PLANTLIST - DANIA BEACH MARINA

REV L2 - DRC COMMENTS DATED 07.06.15

CITY OF DANIA BEACH DRC SUBMITTAL 07.06.15 LANDSCAPE + IRRIGATION NOTES + DETAILS

Date: APRIL 9, 2015 Drawing:

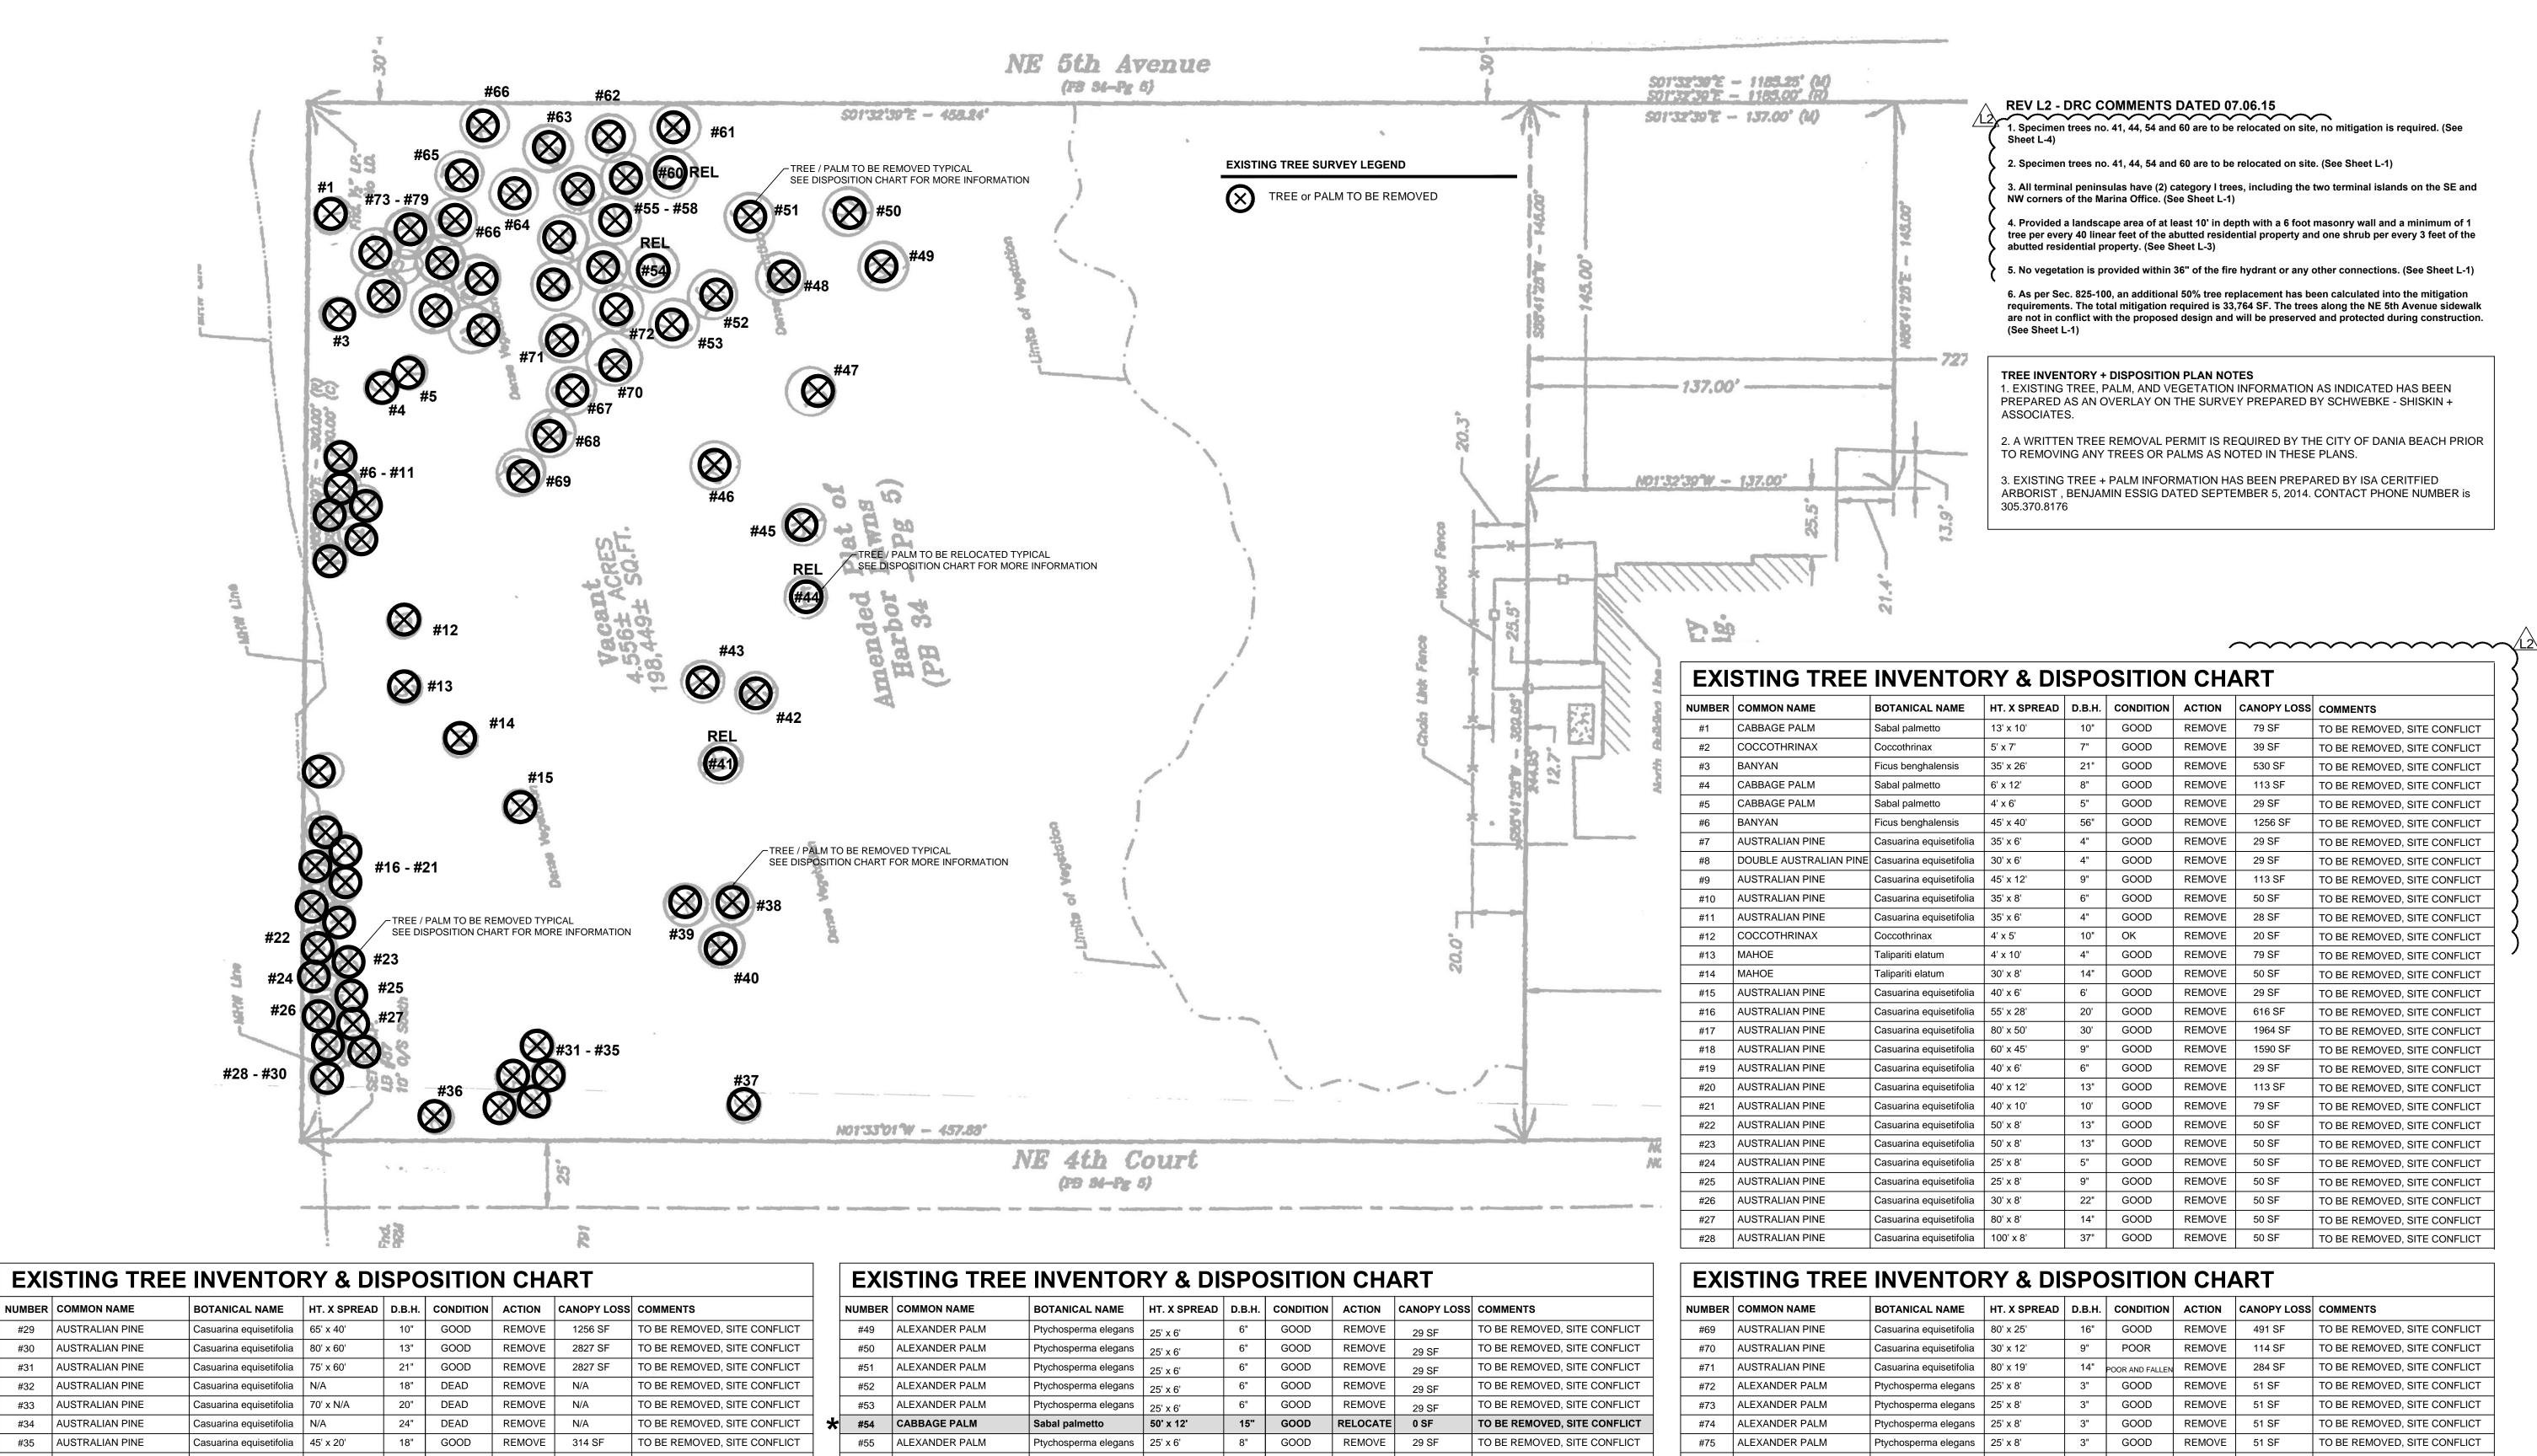
1. Specimen trees no. 41, 44, 54 and 60 are to be relocated on site, no mitigation is

required. (See Sheet L-4)

mitigation requirements. The total mitigation required is 33,764 SF. The trees along the NE 5th Avenue sidewalk are not in conflict with the proposed design and will be preserved and protected during construction. (See Sheet L-1)

6. As per Sec. 825-100, an additional 50% tree replacement has been calculated into the
